WPF4 - Reworking Control Line for Exhaust Flaps (Workshop Campaign)

Vehicle Type: **718 Cayman GT4 RS (982)**

Concerns: **Control line for exhaust flaps**

Oil filler pipe

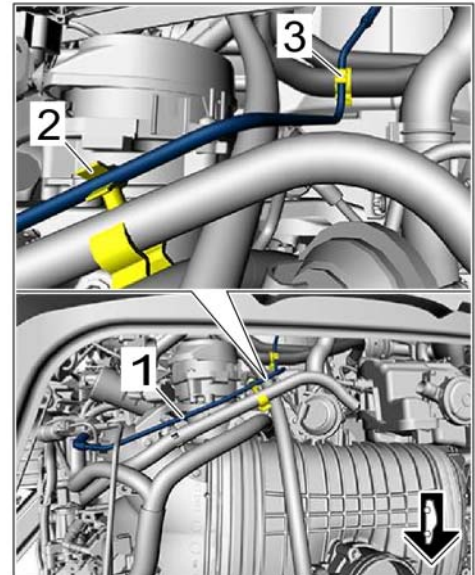
- 2 Disconnect oil filler pipe ⇒ *Oil filler pipe -1-*.
 - 2.1 Releasing and disconnecting quick connector
⇒ *Oil filler pipe -Arrow-*.
 - 2.2 Close off line connections using suitable stoppers.

Control line for exhaust flaps

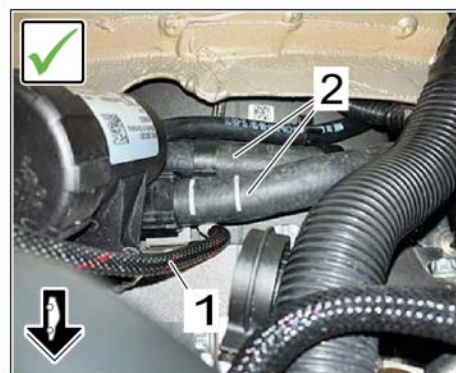
- 4 Guide control line for exhaust flaps ⇒ *New positioning of control line for exhaust flaps -1-under the cooling center hoses* ⇒ *New positioning of control line for exhaust flaps -2-*.

*Previous position of control line
for exhaust flaps*

*New positioning of control line
for exhaust flaps*

The steel flex line must be positioned to the right of the transmission center.

Coolant hose holder

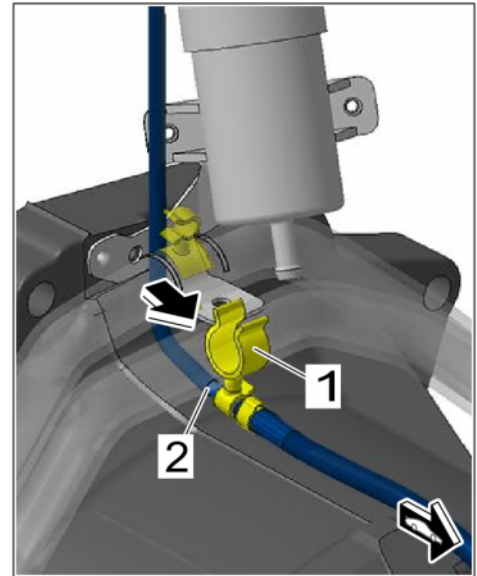
- 5 Re-position holder ⇒ *Coolant hose holder -1-* on **another coolant hose**. Push the sleeve back and clip control line for exhaust flaps ⇒ *Coolant hose holder -2-* into the holder.

Adhesive pad on body

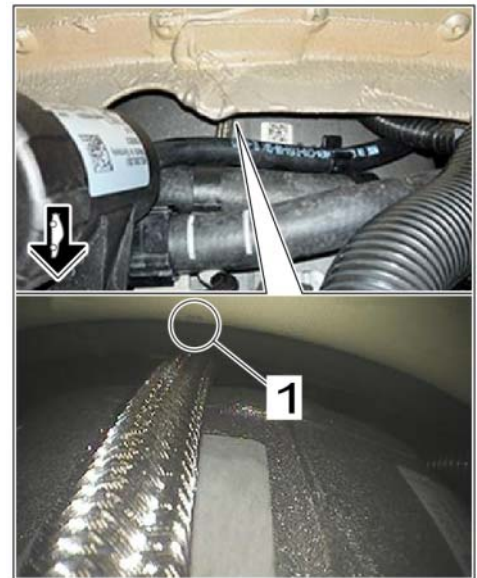
- 6 Apply adhesive pad at the bottleneck ⇒ *Adhesive pad on body -1-* above the control line on the body.

Control line for exhaust flaps

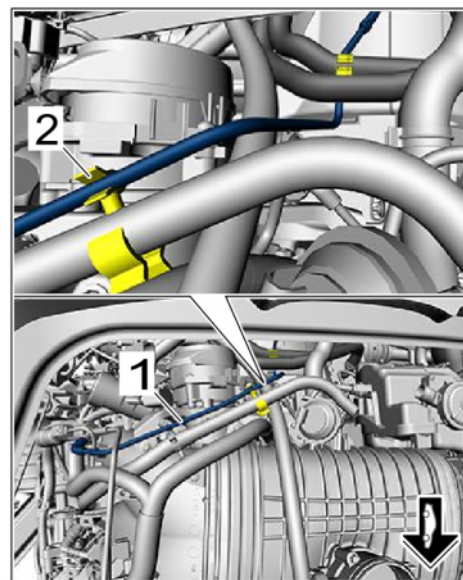
- 7 Connect control line for exhaust flaps ⇒ *Control line for exhaust flaps -1-* to the change-over valve and clip ⇒ *Control line for exhaust flaps -2-* it into the holder.
